Urban Design Observations

Application ref: DM/26/0131

Address: Land South And West Of Upper Imberhorne School Imberhorne Lane East
Grinstead West Sussex

Description: Approval of Reserved Matters following Outline Planning Permission (Ref. DM/23/2699) relating to appearance, landscaping, layout and scale for 550no. new residential units.

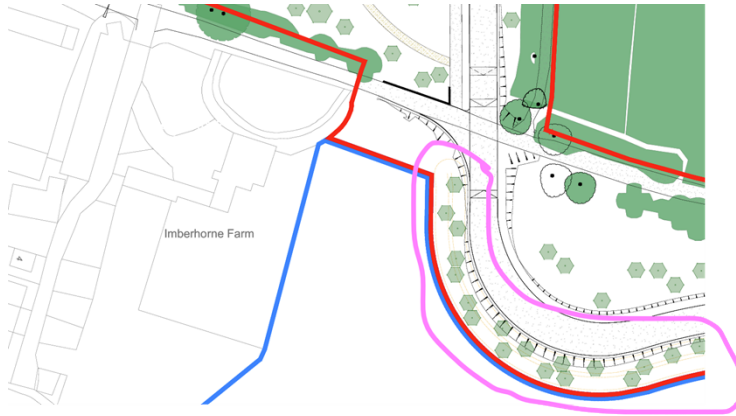
- Add windows to the side elevations on plots 10/11, 14/15, 28/29, 216/217, 220/221, 224/225, 415, 416,
